LOCKHEED AIRCRAFT CORP.		ENGINEERING STUDY <input type="checkbox"/>		LAC -93						
		CHANGE PROPOSAL <input checked="" type="checkbox"/>								
DATE 11-30-60		AFFECTS: WSPO <input checked="" type="checkbox"/>		PROJECT <input checked="" type="checkbox"/>						
NAME OF MAJOR COMPONENT O ₂ SYSTEM		PART OR LOWEST SUBASSEMBLY		PART NO. & MODEL OR TYPE						
TITLE OF PROPOSAL : OXYGEN SYSTEM IMPROVEMENTS										
NATURE OF PROPOSAL: SEE PAGE 2										
REASON FOR PROPOSAL: to incorporate supplemental safety provisions in the ships oxygen system to reduce fire hazard without detriment to existing efficiency. Proposed improvements include:										
<ol style="list-style-type: none"> 1. Use of slow opening manual control valves in place of present automatic opening connectors and the on-off feature of the pressure reducers to eliminate high pressure surges and resulting adiabatic heating. 2. Removing the cockpit low pressure gage to prevent possible misinterpretation of indicated pressures. 3. Relocating the modified pressure reducers and improved relief valves from the cockpit to the Q-bay within a box for protection against grease and dirt. Except for the high pressure gage, only low

FIGURE 1.

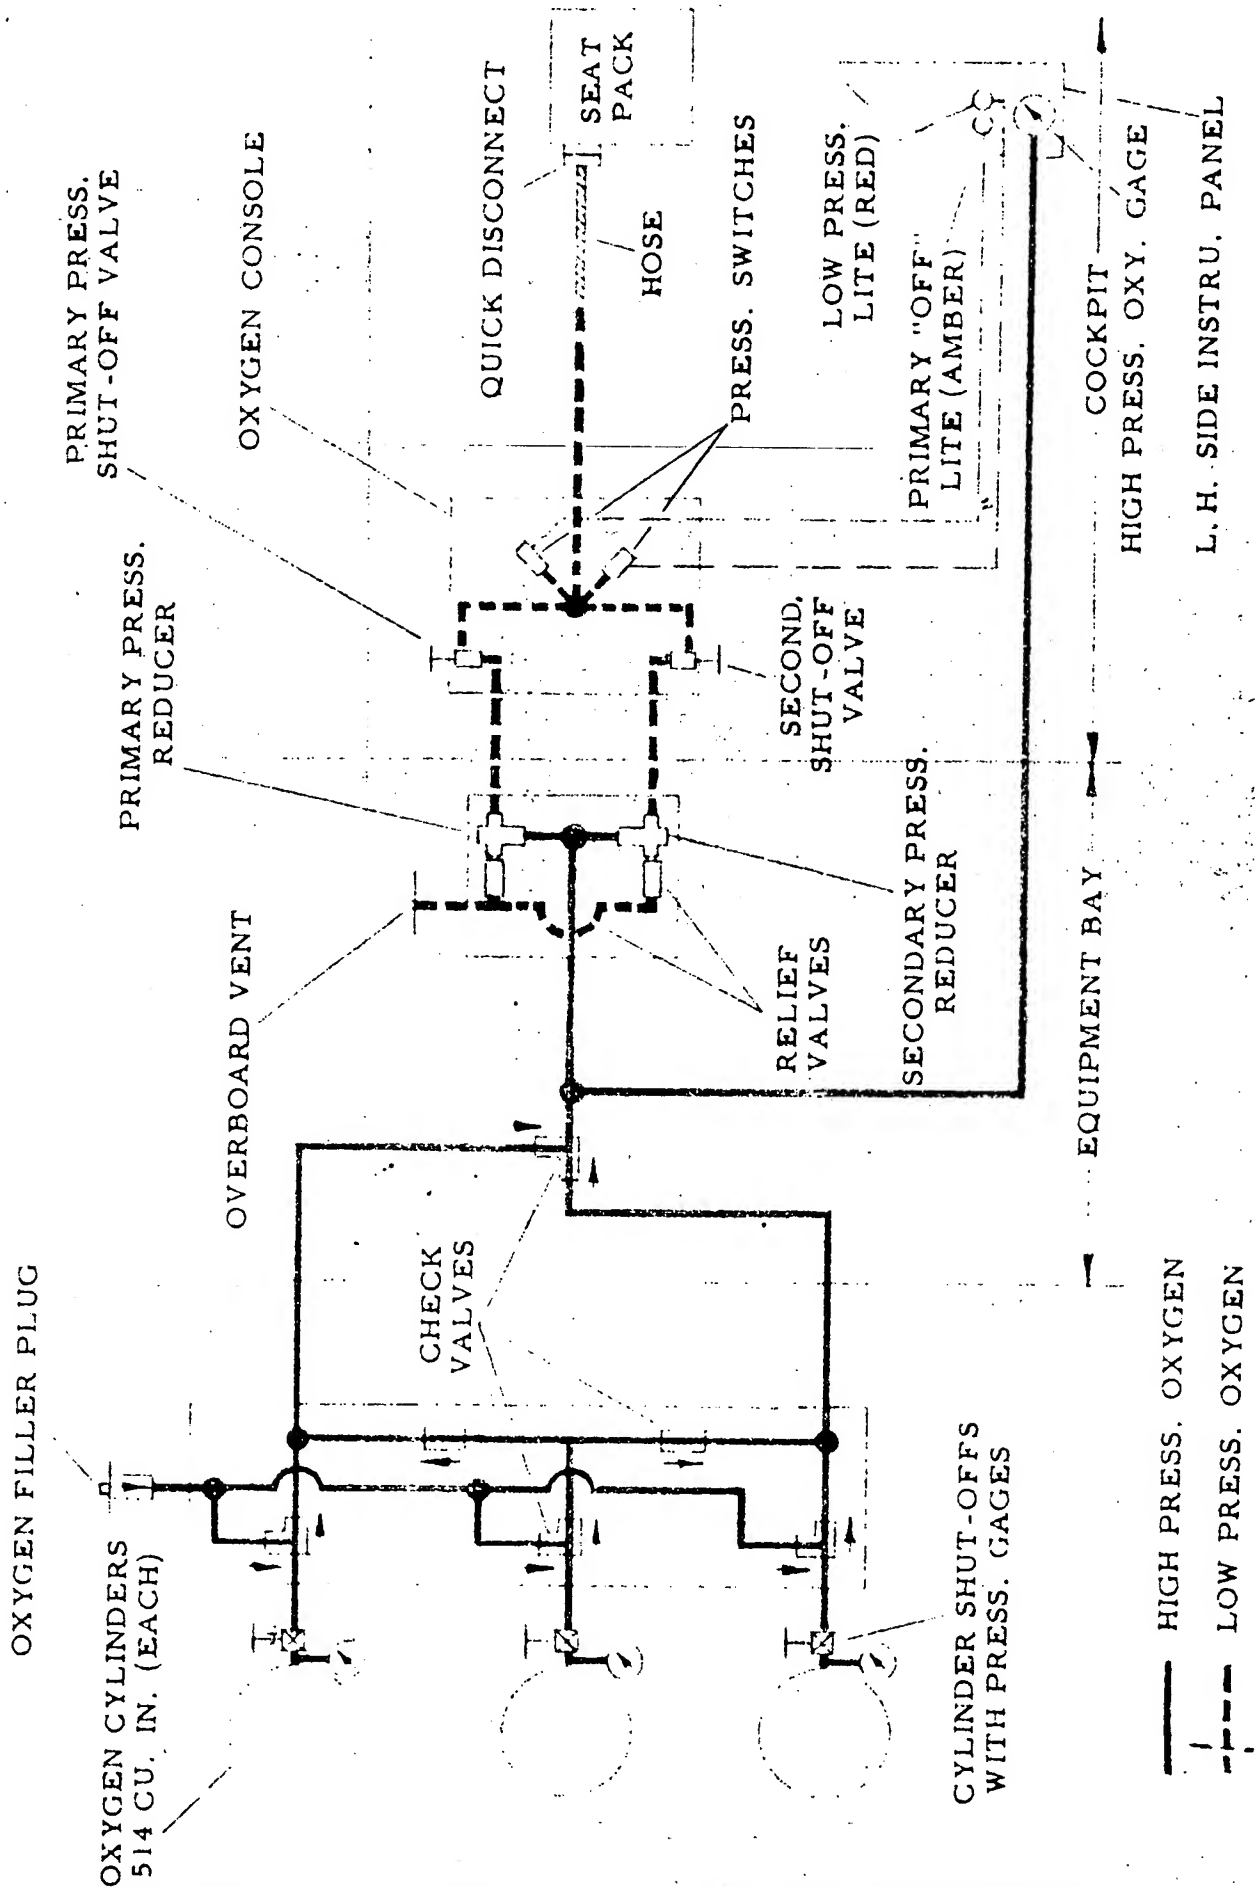
a. Cockpit - Remove all oxygen plumbing and system components except the high pressure gage and the indicator lights in the L. H. side instrument panel. Replace the present Oxygen Console with a new Console Assembly (Lo-pressure only) which includes the two existing pressure switches, and two new slow opening needle valves for controlling the "primary" and "secondary" low pressure systems. (See Figure 1.)
